Case Number: R18029

CASE COMMENTS:

- d. **Existing Stormwater Asset Map possibly affected by the Proposed Development:**

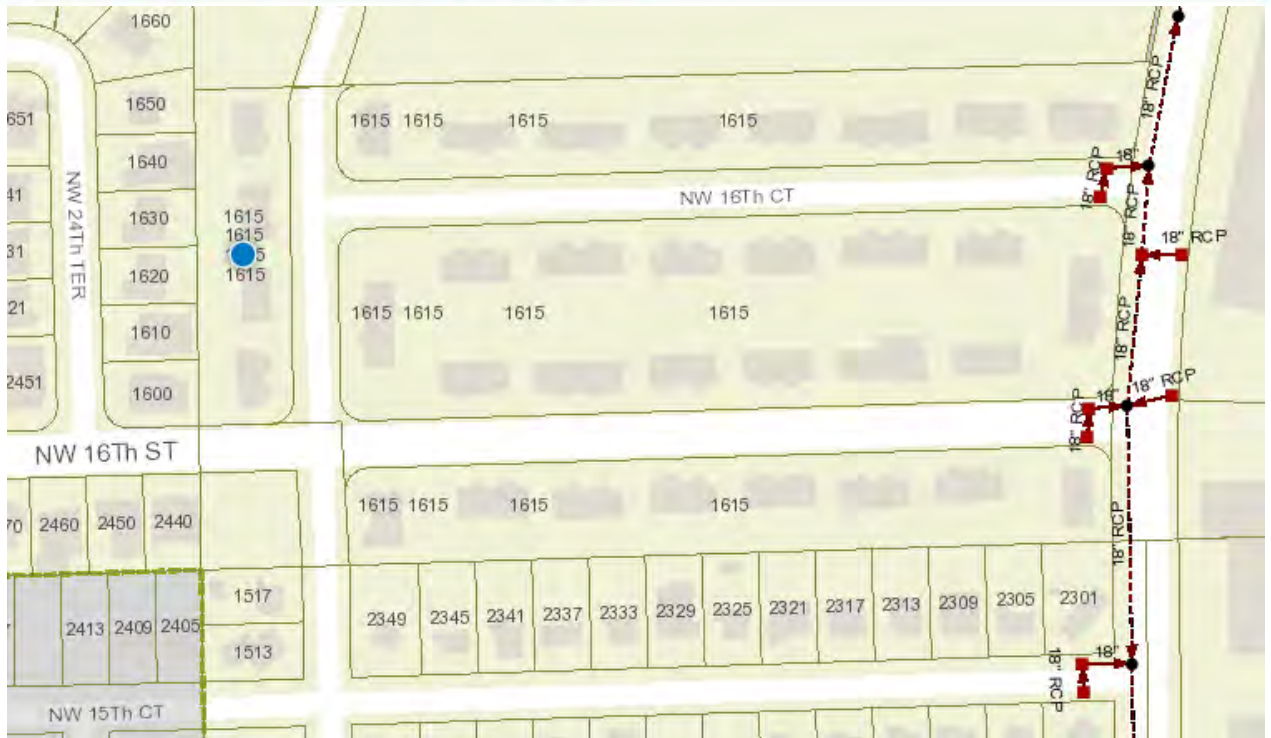
14. The City owns and maintains stormwater infrastructure adjacent to the proposed development as shown with green line work in the map provided at the end of this report. The following comments pertain to possible impacts of the proposed development and/or construction activities to the existing condition of the City's stormwater assets. The applicant shall provide an itemized response letter addressing the following comments:

- a. Please note that no private stormwater infrastructure (drainage pipes, wells, or basins,) can be constructed in City Right of Way or in City drainage easements. Please remove any proposed stormwater systems that are not in compliance with this requirement or provide appropriate documentation of City Rights-of-Way or easement vacated to allow the construction of private underground utilities.

- b. If the development is proposing to remove street swales and construct parallel parking and concrete curbs as shown on the overall site layout, the Civil engineer shall address the City street flood protection criteria & maintenance of City's stormwater assets. Please coordinate requirements with Engineering.
